PROJECT BACKGROUND

Heritage Value and Rationale

Request to TPB

Above: Rendered view by HPA, March 2023 / Right: 1942 Belsize Theatre, Toronto Archives (both annotated by ERA)

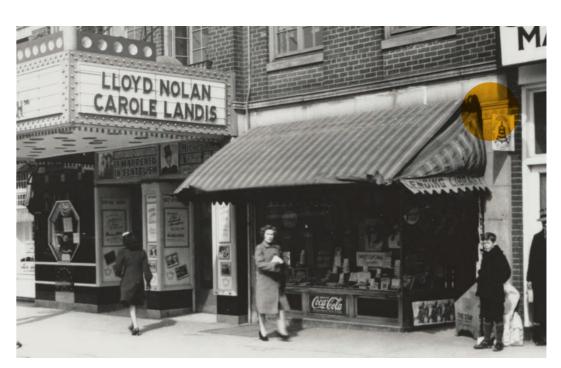
Condition: "Conserve the stone detailing on the extant piers, including the 'teardrop' forms on the capitals and the stone detailing on the concentric planes on the north entrance surround."

Proposed Response: Truncate new canopy's width to end inside the capitals, and restore damaged teardrops.

NORR, June 2023, annotated by ERA

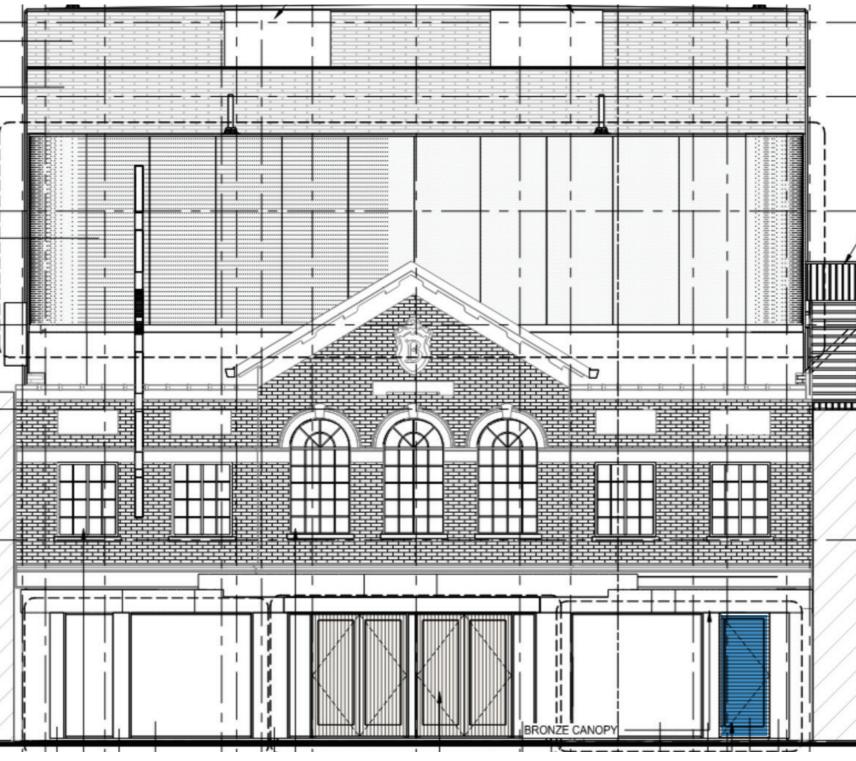
Condition: "Conserve the stone detailing on the extant piers, including the 'teardrop' forms on the capitals and the stone detailing on the concentric planes on the north entrance surround."

Proposed Response:

Exclude the stone detailing on the north entrance surround, as secondary entrance to be located at south end.
